City of Medford
ADA ACCESSIBILITY TRANSITION PLAN
revised July 10, 1992

**AMERICANS WITH DISABILITIES ACT
COMPLIANCE REVIEW**

**MEDFORD CITY HALL
MEDFORD SERVICE CENTER**

JULY 8, 1992

FIRST FLOOR PLAN
1/8" = 1'-0"

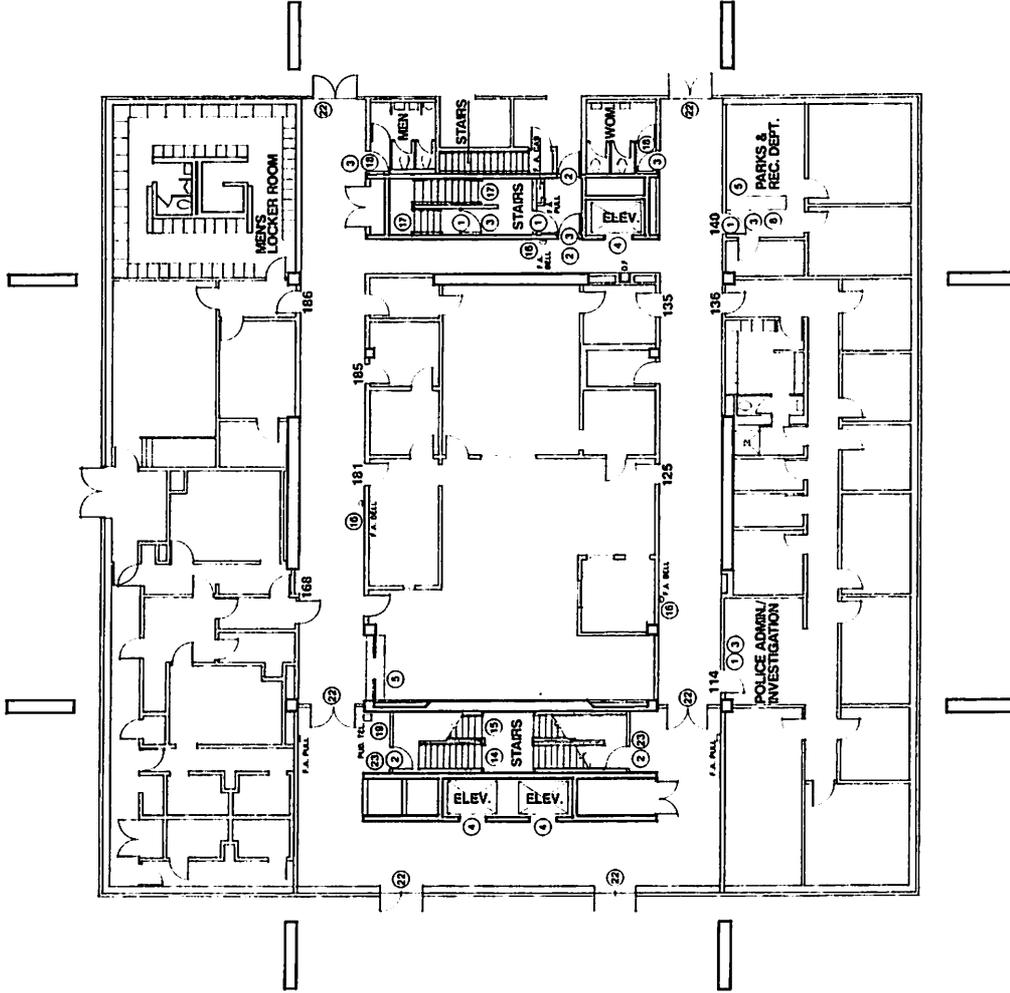
- A. Room 140 - Parks & Recreation
1. Entry Door 140 needs lever handle \$ 250.00
 2. Signage needed at door \$ 150.00
 3. Public counter needs handicapped access area

<u>EST. COST</u>
B. Room 144 - Police	
1. Entry Door 144 needs lever handle	\$ 250.00
2. Signage needed at door	\$ 150.00
C. Public Counter in East Hallway (Police)

1. Needs handicapped accessible area	
Solution: Lower counter or,	\$ 500.00
Alternative: Because of concern about security, provide assistance to handicapped to a desk at a nearby location.	-0-

D. Elevators	
1. Need handicapped signage, controls, etc. Car size and entry width o.k.	N/A
Solution: Contact elevator co. for requirements and cost.	
E. Men's & Women's Restrooms	\$ 150.00

1. Door needs signage	
2. Not handicapped accessible or equipped.	
Solution: Provide directional signing to 2nd floor.	\$ 150.00
F. Public Telephone	
1. Needs shelf with elec. outlet.	\$ 300.00

G. Stairways	
1. Doors need panic hardware 3@ 600	\$ 1,800.00
2. Signage required at doors 3 @ 150	\$ 450.00
3. Front stair handrails don't comply (need grip/too wide [2"])	
Solution: Remove modify and reinstall existing hand rails.	\$ 3,000.00

H. Main Exterior Doors	
1. Opening force greater than maximum allowed	
Solution: Provide one automatic door assembly on accessible route (rear entry).	\$ 7,000.00

I. Corridors	
1. Both pairs of interior doors require greater than 5 LBF to operate. (If bldg. accessible from rear entry they are o.k.)	-0-
2. Visual alarms required at all audible alarm stations at 50' o.c. max. 3 @ 300.	\$ 900.00

1. DOOR NEEDS LEVER HANDLE.
2. DOOR NEEDS PANIC HARDWARE.
3. DOOR NEEDS SIGN.
4. DOOR NEEDS SIGN, COURTY.
5. PUBLIC COUNTER NEEDS TO BE LOWERED FOR HANDICAPPED.
6. ACCESS TO STOVE OR SINK & COUNTER NOT ADEQUATE FOR HANDICAPPED.
7. TOILET STALL NOT HANDICAPPED ACCESSIBLE.
8. 5' (60") TURNAROUND SPACE NOT PROVIDED.
9. SINK TOO HIGH.
10. NOT ENOUGH CLEARANCE IN FRONT OF LAV.
11. MIRROR TOO HIGH.
12. LEVEL FACETS REEDS AT LAV.
13. DRINKING FOUNTAIN DOESN'T COMPLY (TO HIGH).
14. HANDRAILS DO NOT COMPLY.
15. TREADS SQUARE EDGE DON'T COMPLY.
16. NEEDS VISUAL ALARM LOCATION.
17. HANDRAIL ENDS NEED TO EXTEND BEYOND TREAD.
18. DOOR TO HALLWAY.
19. TELEPHONE NEED SHELF.
20. NEEDS WHEELCHAIR ACCESS.
21. NEEDS WHEELCHAIR SEATING AREA.
22. DOOR SWING EXCEEDS 5' CLR.
23. DOOR SWING EXCEEDS 5' CLR.
24. LINTYORT DRAIN PIPE EXPOSED.

SECOND FLOOR PLAN
1/8"=1'-0"

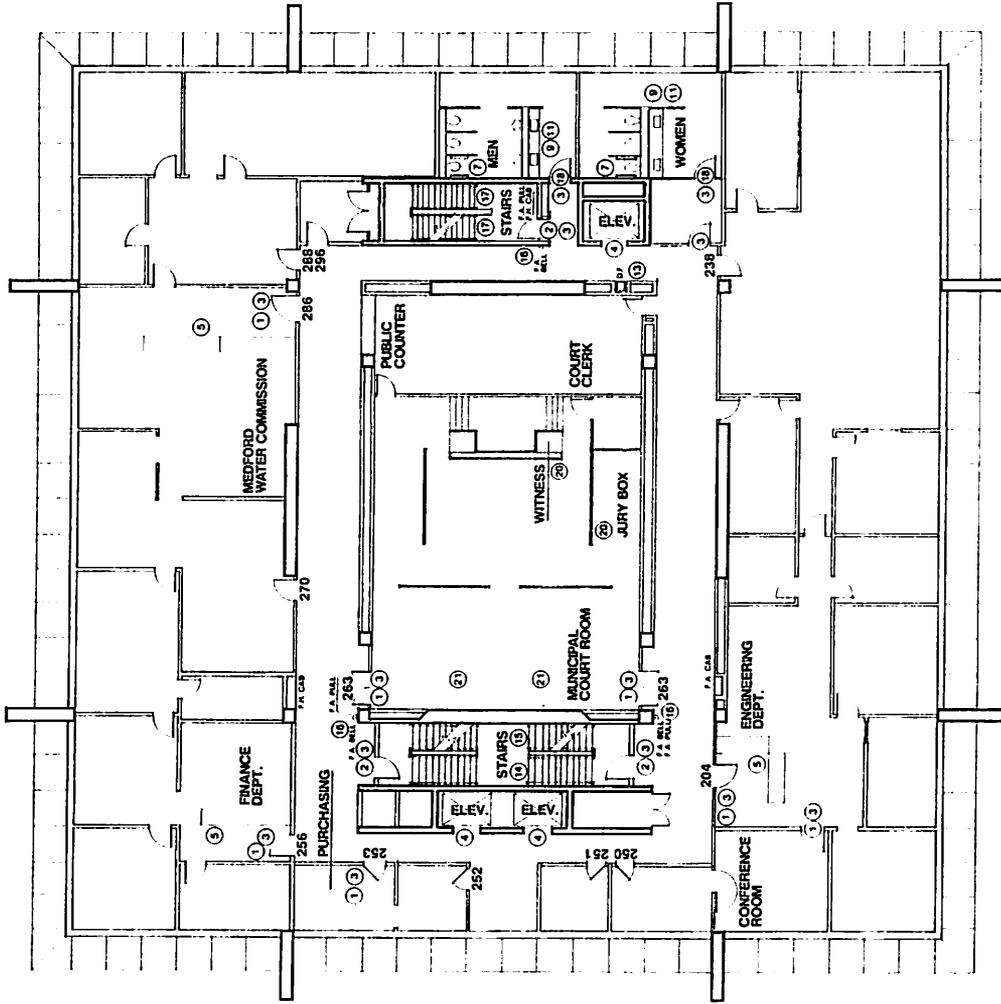
A. Room 204 - Engineering Division	
1. Entry door needs lever handle	\$ 250.00
2. Signage required at door	\$ 150.00
3. Public counter needs handicapped section

<u>EST. COST</u>
Solution:	
1. Lower section of counter; or	\$ 500.00
2. Provide access to desk and assistance	-0-
B. Conference Room	
1. Entry door needs lever handle	\$ 250.00

2. Signage required at door	\$ 150.00
C. Room 256 - Finance Department	
1. Entry door needs lever handle	\$ 250.00
2. Signage required at door	\$ 150.00
3. Public counter needs handicapped access section	
Solution:

1. Lower section of counter; or	\$ 500.00
2. Provide access to desk and assistance	-0-
D. Room 263 - Municipal Courtroom	
1. Both pairs of entry doors need pull more than 5 LBF.	
Solution:

1. Replace one set of doors with easier operating doors, or	\$ 2,000.00
2. Provide separate handicapped entry	\$ 1,000.00
3. Provide assistance to handicapped.	-0-

2. Signage required at entry doors	\$ 300.00
3. Public seating 48 (26050 requires 2 wheelchair locations.	
Solution: Remove 2 sections of seats (4) to provide room for wheelchair/repair floor.	\$ 300.00

4. Municipal court public counter in hallway needs handicapped accessible area.	
Solution:	
1. Lower a section of counter	\$ 500.00
2. Because of security provide assistance to a standard desk location.	-0-

5. Jury box and witness stand step up 4' (Not accessible)	
Solution: Provide portable ramp for use when needed.	\$ 500.00
E. Room 286 - Water Department

1. Entry door needs lever handle	\$ 250.00
2. Signage required at door	\$ 150.00
3. Counter needs handicap access area	
Solution: Lower section of counter	\$ 500.00

F. Men's & Women's Restrooms	
1. Signage at door	\$ 150.00
2. Door too narrow - widen or relocate 2 @ 800	\$ 1,600.00

<u>EST. COST</u>
3. Handicapped toilet stall too small - lengthen to 66"	\$ 500.00
4. Towel dispenser too high- lower	\$ 50.00
5. Mirror too high - only 1' too high leave as is.	-0-

6. Lavatory counter not high enough, not enough clearance under - close enough.	-0-
G. Elevators	
1. Signing, controls, etc.	
Solution: Contact elevator company for req's and cost.	N/A

H. Stairs - Front and back stair entry doors	
1. Need panic hardware 3 @ 600	\$ 1,800.00
2. Signing required 3 @ 150	\$ 450.00
3. Hand rails - front stair (See 2G.)

I. Corridors	
1. Visual alarms required at all audible alarm stations.	
Solution: Add strove lights 3 @ 300	\$ 900.00
2. Drinking fountain not handicapped accessible	
Solution: Lower drinking fountain	\$ 200.00
IV. THIRD FLOOR

1. DOOR NEEDS LEVER HANDLE.
2. DOOR NEEDS PANE HARDWARE.
3. DOOR NEEDS PANE HARDWARE.
4. ELEVATOR DOESN'T COMPLY.
5. PUBLIC COUNTER NEEDS TO BE LOWERED FOR HANDICAPPED.
6. ACCESS TO STOVE OR SINK & COUNTER NOT ADEQUATE FOR HANDICAPPED.
7. TOILET STALL NOT HANDICAPPED ACCESSIBLE.
8. TOILET STALL NOT HANDICAPPED ACCESSIBLE.
9. TOWEL DISPENSER TOO HIGH.
10. NOT ENOUGH CLEARANCE IN FRONT OF LAV.
11. MIRROR TOO HIGH.
12. LEVEL FAUCETS READ AT LAV.
13. DRINKING FOUNTAIN DOESN'T COMPLY (TO HIGH).
14. HANDRAILS DO NOT COMPLY.
15. MIRROR PREVENTS ELEVATOR COMPLY.
16. AUDIBLE PRE-ALARM LOCATION NEEDS VISUAL ALARM.
17. HANDRAIL ENDS NEED TO EXTEND BEYOND TREAD.
18. DOOR TOO NARROW.
19. TELEPHONE NEED SHELF.
20. NEEDS WHEELCHAIR ACCESS.
21. NEEDS WHEELCHAIR SEATING AREA.
22. NEEDS WHEELCHAIR SEATING AREA.
23. DOOR SWINGS WRONG WAY.
24. LAVATORY DRAIN PIPE EXPOSED.

FLOOR PLAN
1/8" = 1'-0"
0 5 10
NORTH

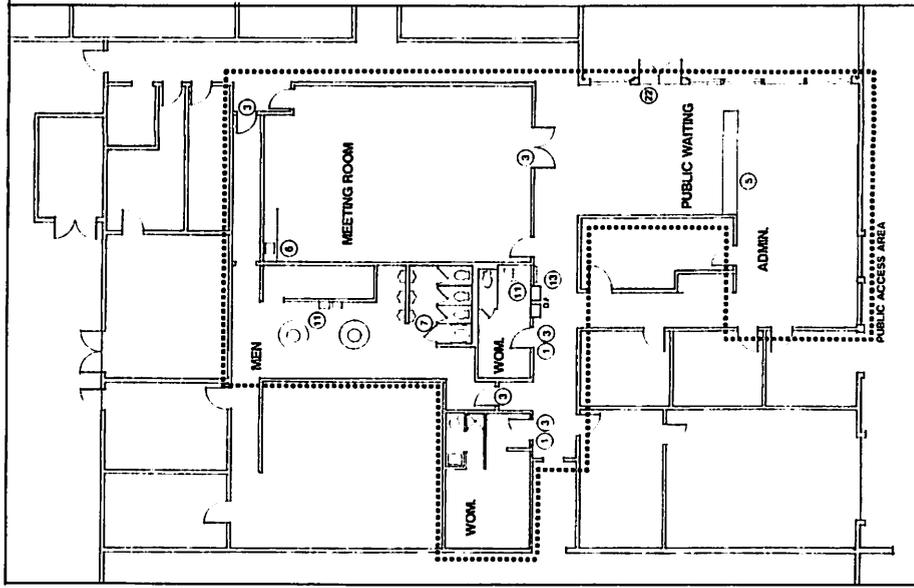
B. Interior	
1. Public Waiting Rooms	
a. Entry doors required operating force greater than 5 LBF max.	
Solution:	
1. Install automatic doors	\$ 7,000.00
2. Install call button and provide assistance	\$ 200.00

b. Public counter needs handicapped accessible area	
Solution: Lower section of counter	
2. Meeting Room	
a. Entry doors need signage	\$ 150.00
3. Men's Restroom

a. Both doors need signage	\$ 300.00
b. Front approach at strike side of doors not adequate width cost to change would be unreasonable to change.	-0-
c. Mirror too high.	
Solution: Lower to 40"	\$ 50.00

d. Pipe under lavatory needs to be insulated	
e. Handicapped toilet stall too small.	
Solution: Extend to 66" in depth	\$ 300.00
4. Women's Restroom	
a. Entry door needs signage	\$ 150.00

b. Handicapped stall too small	
Solution: Extend to 66" in depth	\$ 300.00
c. Lavatory counter too low, not enough clearance under	
Solution: Modify counter	\$ 300.00

d. Mirror too high	
Solution: Lower mirror	\$ 50.00
5. Corridor	
a. Handicapped drinking fountain too high	
Solution: Lower drinking fountain.	\$ 200.00

SITE PLAN
NO SCALE
NORTH

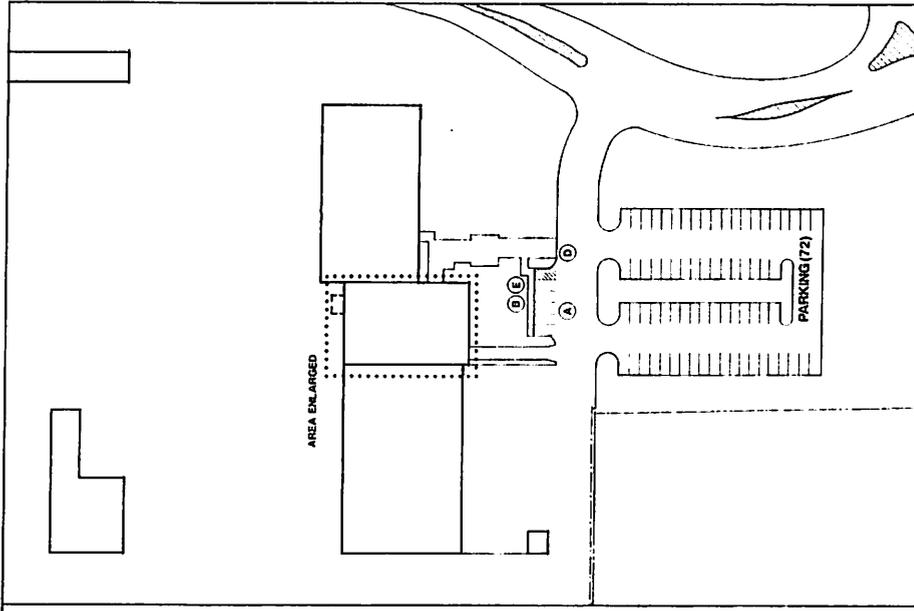
A. Exterior	
1. Parking - 75 parking spaces are now provided. Need 3 handicapped stalls, only 1 provided. One needs to be for a van, also need accessible route to main entry.	
Solution:

1. Re-stripe public parking of parking lot nearest the front of the building, or	\$ 150.00
2. Modify sidewalk to provide accessible route from 3 handicapped stalls.	\$ 800.00

<u>EST. COST</u>
2. Need passenger loading zone 60" wide x 20' wide with direct access to accessible route to front doors.	
Solution: Modify sidewalk.	\$ 400.00

- A. NEED ADDITIONAL HANDICAPPED STALL/VAN STALL
 - B. ACCESSIBLE ROUTE
 - C. HANDICAP REQUIRED
 - D. PASSENGER LOADING AREA REQUIRED
 - E. RAMP NEEDS DETECTABLE WARNING
- FOR DRAWING NOTES 1-24 REFER TO PREVIOUS PAGE.

SITE PLAN
1"=30'-0"
0 10 20 30
NORTH

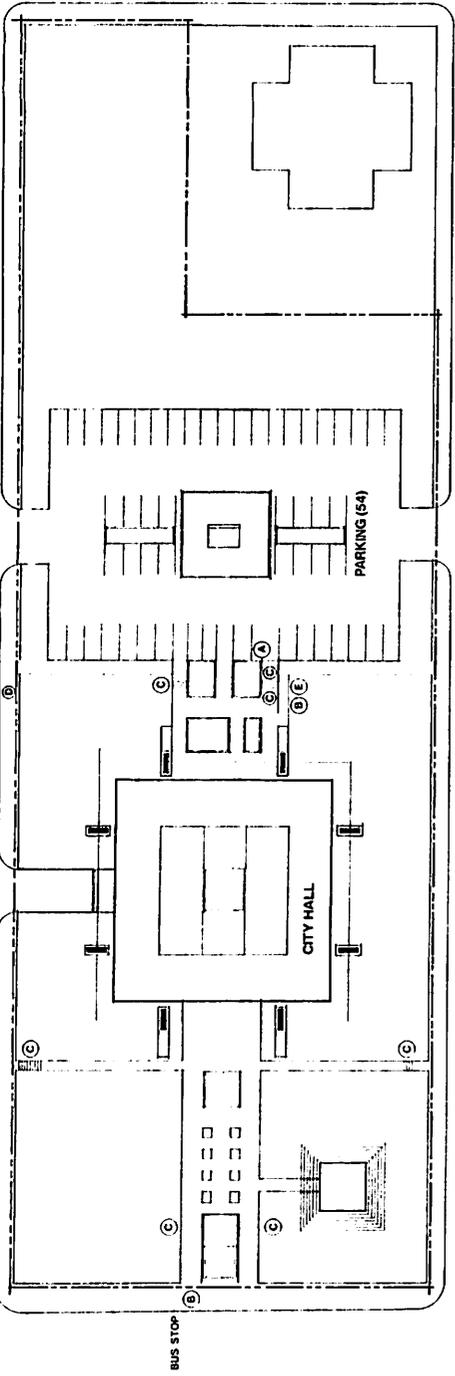
- A. Parking - 54 parking spaces provided
2 Handicapped spaces provided,
3 are required (51-75 = 3 required)
(1 space for vans) need accessible route from each
handicapped parking stall to ramp.

- B. Accessible Route - At least one from public transportation stops, one is provided at rear of building, bus stop is at front on 8th Street. This is too far to travel. Rear ramp railing doesn't comply.

- C. Need passenger loading zone 60" wide x 10' along with direct access to accessible route. Best location Ivy Street next to east west rear sidewalk.

- D. Curb Ramps - Need detectable warning 36" wide where a walk crosses or adjoins a vehicle way.

- E. Front Main Steps (at Eighth Street) (2) and East Steps at Ivy & West Steps Oakdale need handrails.

- A. NEED ADDITIONAL HANDICAPPED STALL, VAN STALL
B. ACCESSIBLE ROUTE
C. HALLWAY REQUIRED
D. PASSENGER LOADING AREA REQUIRED
E. RAMP NEEDS DETECTABLE WARNING.

1. Re-stripe parking area next to ramp. \$ 100.00
2. Modify sidewalk to provide accessible route from 3 spaces. \$ 1,000.00

1. Provide accessible route from existing bus stop on 8th Street with signing and new ramp to front entry of City Hall. \$ 2,000.00
2. Relocate bus stop to Ivy Street next to east west sidewalk to rear entrance. Provide signing. \$ 300.00

Solution: Replace 20 feet wide section of sidewalk with curb ramps. \$ 400.00

1. Saw cut grooves in paving or concrete; or \$ 1,000.00
2. Apply "Ribbed strip to paving or concrete. \$ 500.00

Solution: Install handrails as required. \$ 3,000.00

BASEMENT PLAN
1/8"=1'-0"
0 5 10
NORTH

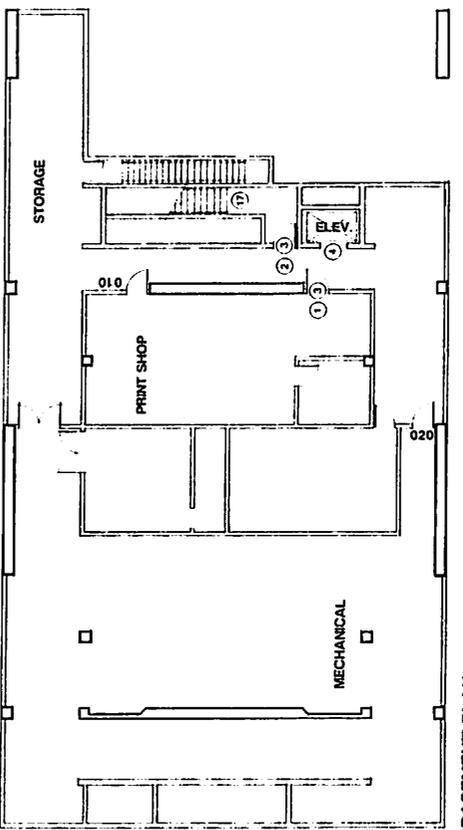
1. DOOR NEEDS LEVER HANDLE.
 2. DOOR NEEDS S.W. H.W.
 3. DOOR NEEDS S.W. H.W.
 4. ELEVATOR DOESN'T COMPLY.
 5. PUBLIC COUNTER NEEDS TO BE LOWERED FOR HANDICAPPED.

6. ACCESS TO STOVE OR SINK & COUNTER NOT ADEQUATE FOR HANDICAPPED.
 7. CITY HALL NOT HANDICAPPED ACCESSIBLE.
 8. SINK TUB NOT HANDICAPPED ACCESSIBLE.
 9. TOWEL DISPENSER TOO HIGH NOT PROVIDED.

10. NOT ENOUGH CLEARANCE IN FRONT OF LAV.
 11. MIRROR TOO HIGH.
 12. LEVEL FAUCET'S REED AT LAV.
 13. DRINKING FOUNTAIN DOESN'T COMPLY (10 HIGH).
 14. HALLWAY TOO NARROW.

15. TREADS FOR ELEVATOR DOESN'T COMPLY.
 16. AUDIBLE FIRE ALARM LOCATION NEEDS VISUAL ALARM.
 17. HALLWAY ENDS NEED TO EXTEND BEYOND TREAD.
 18. DOOR TOO NARROW.

19. TELEPHONE NEED SHELF.
 20. NEEDS WHEEL CHAIR ACCESS.
 21. NEEDS WHEEL CHAIR SEATING AREA.
 22. DOOR PULL EXCEEDS 5 LBS.
 23. DOOR SWINGS WRONG WAY.
 24. LAVATORY DRAIN PIPE EXPOSED.
